**FINAL ENVIRONMENTAL ASSESSMENT
CHAPTER 343, HAWAII REVISED STATUTES (HRS)
ENVIRONMENTAL ASSESSMENT (EA)/DETERMINATION
FINDING OF NO SIGNIFICANT IMPACT (FONSI)**

Applicant : Edward J., Jr. and Kathryn Weldon
Agent : Analytical Planning Consultants (Donald A. Clegg)
Location : 4771 Kahala Avenue - Kahala
Tax Map Key : 3-5-6: 6
Request : After-the-fact Shoreline Setback Variance
Proposal : To retain unauthorized sand fill within the 40-foot shoreline setback area

FINAL ENVIRONMENTAL ASSESSMENT

**SHORELINE SETBACK VARIANCE FOR
IMPROVEMENTS AT 4771 KAHALA AVENUE**

2004 Certified Shoreline Survey – Official Photos Submitted to DLNR – Taken November 3, 2003

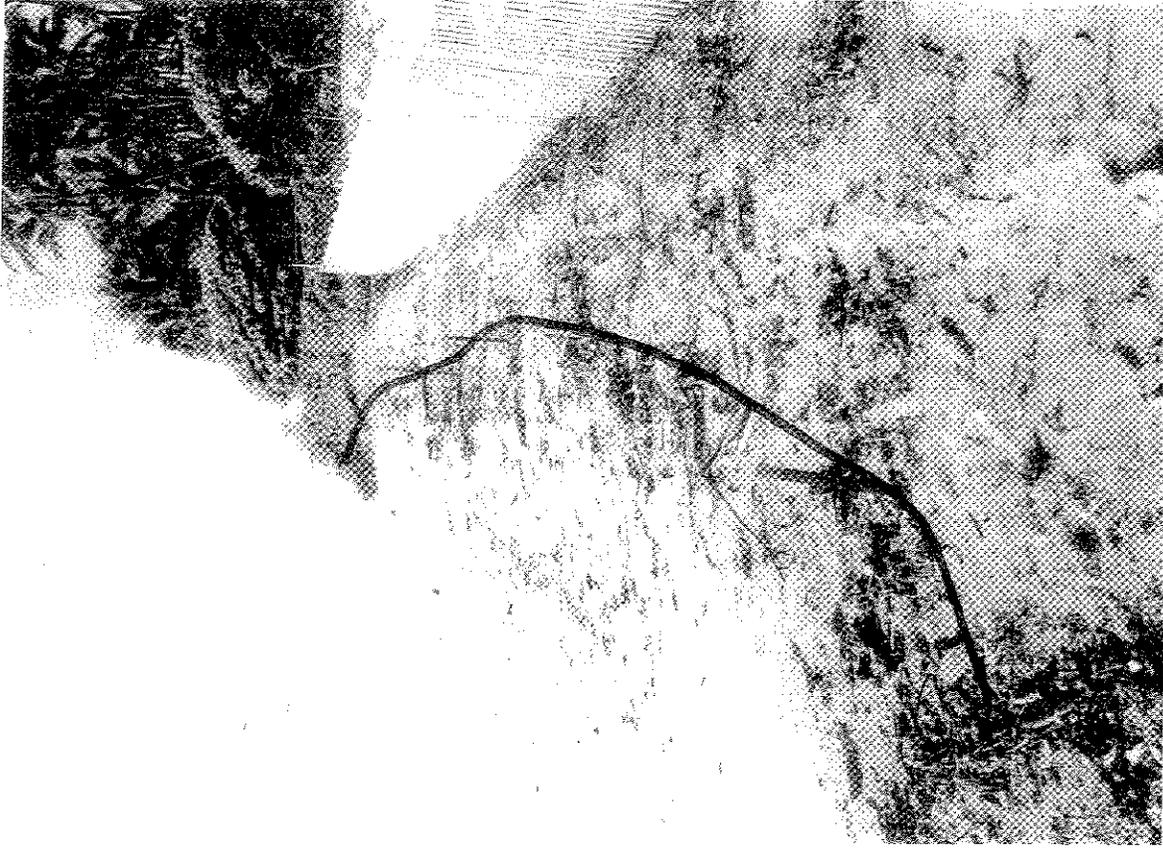
The applicant also mentions that a certified shoreline was completed on February 11, 2004. This office recognizes that this shoreline is already certified but feels that it may have been certified in error and is more accurately located just mauka of the existing fence at the base of the sand berm as illustrated in the applicant's photos in Figure 5.

Figure 7
1987 Certified Shoreline Survey
4771 Kahala Avenue, Honolulu, Oahu, Hawaii

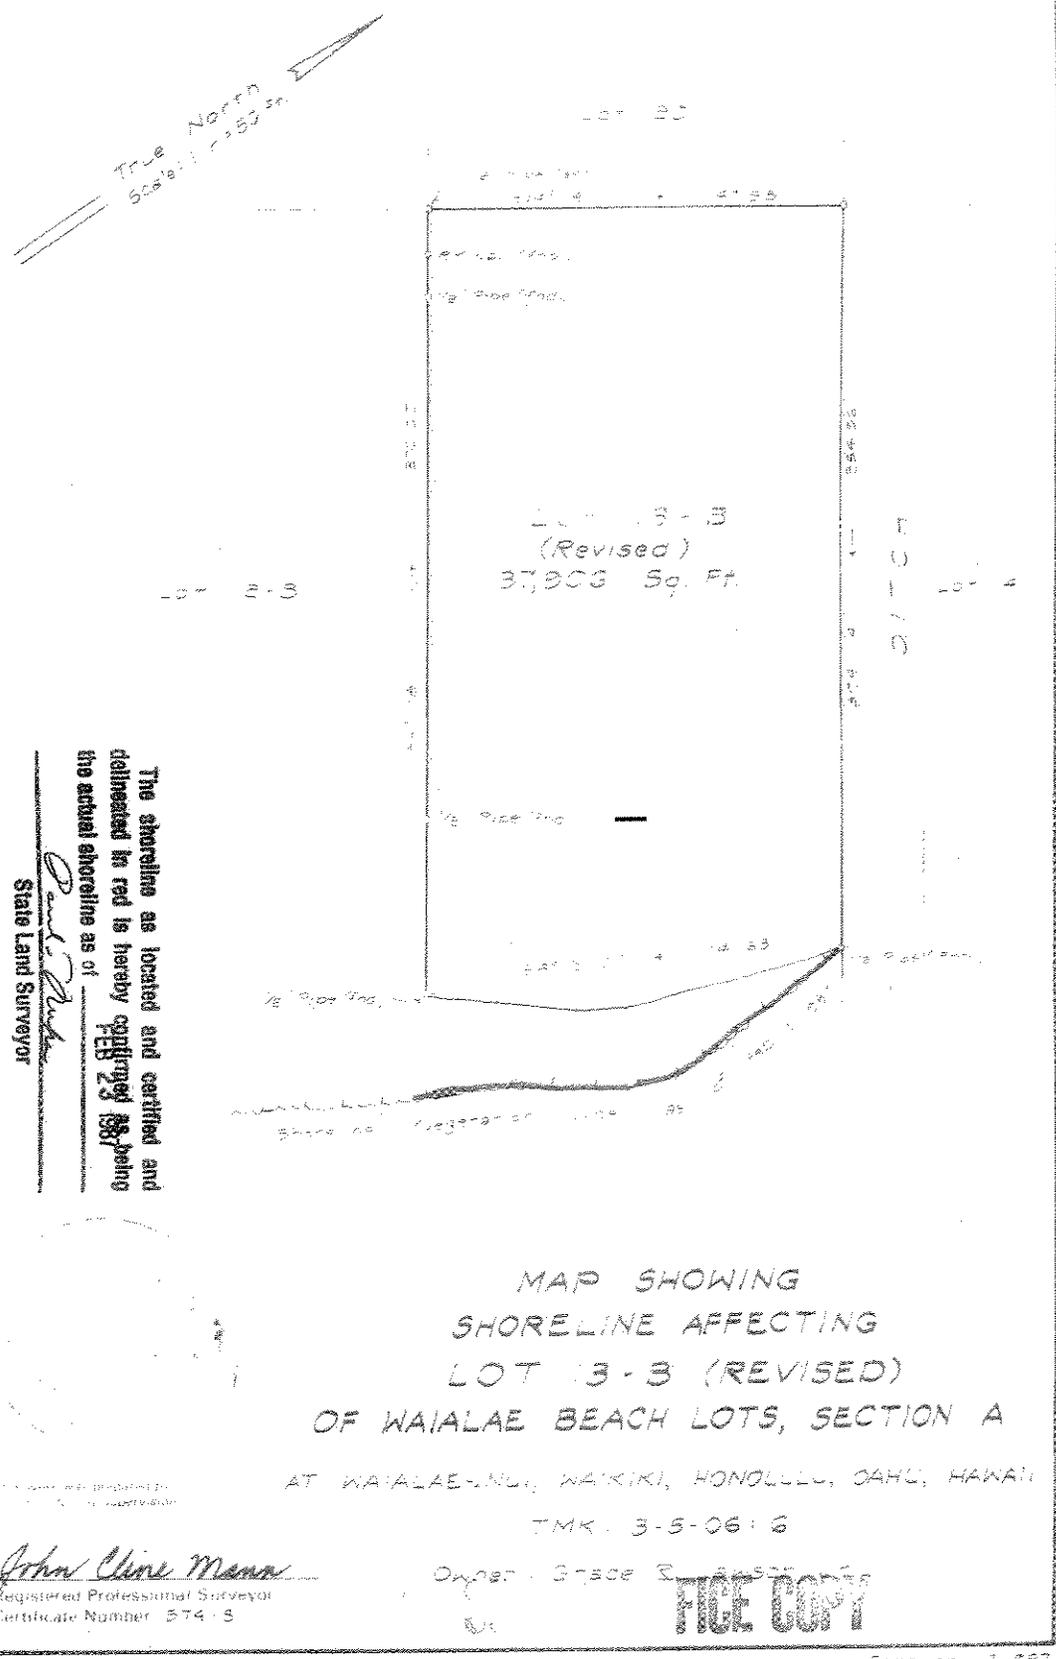
The applicant has failed to adequately address the potential impact of the proposed structure on the littoral processes, specifically longshore and cross-shore transport of sediment. The applicant states the proposed structure will have no impact on shoreline processes because the footings will be buried and no portion of the structure will be exposed. The Department disagrees with this statement and suggests that the structure will be regularly exposed as Figure 7 of the DEA illustrates.
